EOG proposes to P&A this wellbore using the attached procedure. Current and Proposed wellbore schematics attached.

STW 25 State COM #1 – P&A Procedure

API # 30-015-30493

Operator: EOG RESOURCES INC 5509 Champions Drive Midland, TX 79706	OGRID: 7377
	Action Number: 385285
	Action Type: [C-103] NOI Plug & Abandon (C-103F)

Proposed Wellbore Diagram:

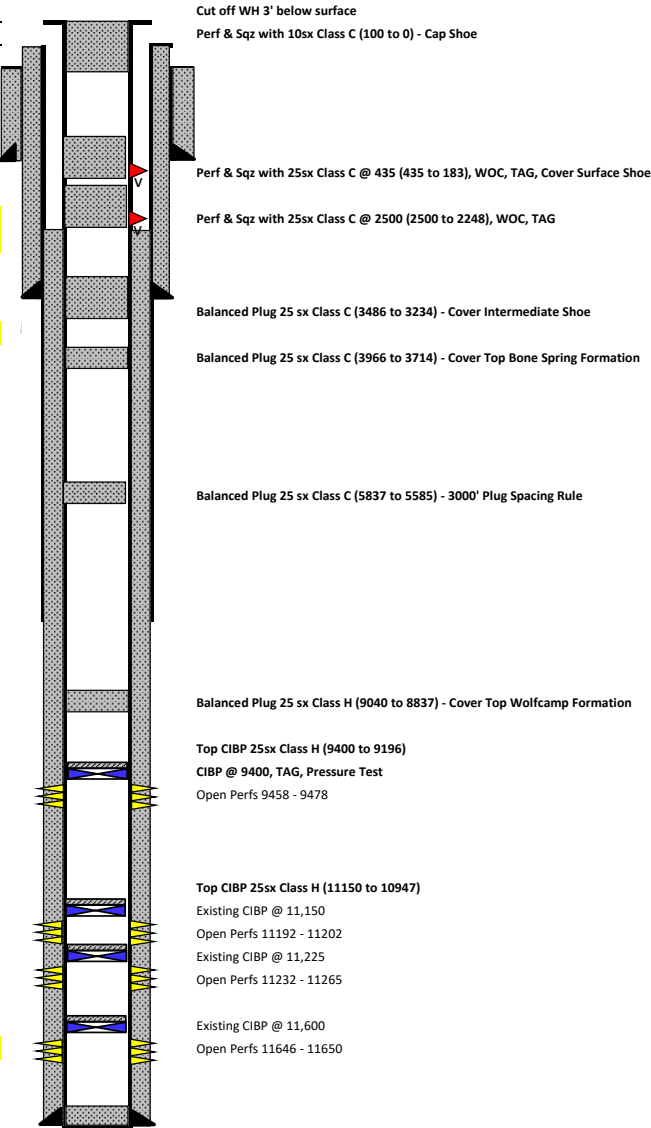
SEE ATTACHED COA's

Created By	Condition	Condition Date
gcordero	CBL must be submitted to OCD via OCD Permitting prior to submitting C-103P	10/1/2024

1. Notify Regulatory Agency 24 hours prior to commencing work. MIRU well service unit and all necessary safety equipment.
2. ND WH, NU BOP.
3. Unset Anchor, POOH and LD 2.875" TBG. PU WS and prep for P&A.

4. Drill out plugs at 11150' & 11225'
5. Spot 4 sx cmt on plug @ 11600'
6. Set CIBP @ 11225' and spot 4 sx cmt
7. Set CIBP @ 11140.- Test Plug 500psi/30min

8. Top CIBP w/ 25 sx Class H on CIBP from 11150 to 10947
9. Spot 36 sx cmt 10620' - 10286' - T Atoka & Strawn
10. RIH to set CIBP at 9400, TAG, and pressure test Casing 500psi/30 minutes.

11. Circulate plugging mud
12. RIH and run CBL to Surface
13. RIH, top CIBP w/ 25 sx Class H on CIBP from 9400 to 9196
14. Pick up, set balanced plug w/ 25 sx Class H from 9040 to 8837 -50' below Wolfcamp formation.

15. Pick up, set balanced plug w/ 25 sx Class C from 5837 to 5585 for 3000' spacing rule
16. Pick up, set balanced plug w/ 25 sx Class C from 3966 to 3714 to -50' below Bone Spring formation.

17. Pick up, set balanced plug w/ 25 sx Class C from 3486 to 3234 for -50' below Intermediate shoe.
18. Pick up, perf & sqz w/ 25 sx Class C at 2500 (2500 to 2248), WOC, TAG.

19. Pick up, perf & sqz w/ Class C at 435 (435 to 0) for Surface shoe,
20. Cut off WH 3' below surface, verify cement to surface, and weld on below ground P&A marker.

21. Cut off anchors 3' below surface and clean location.
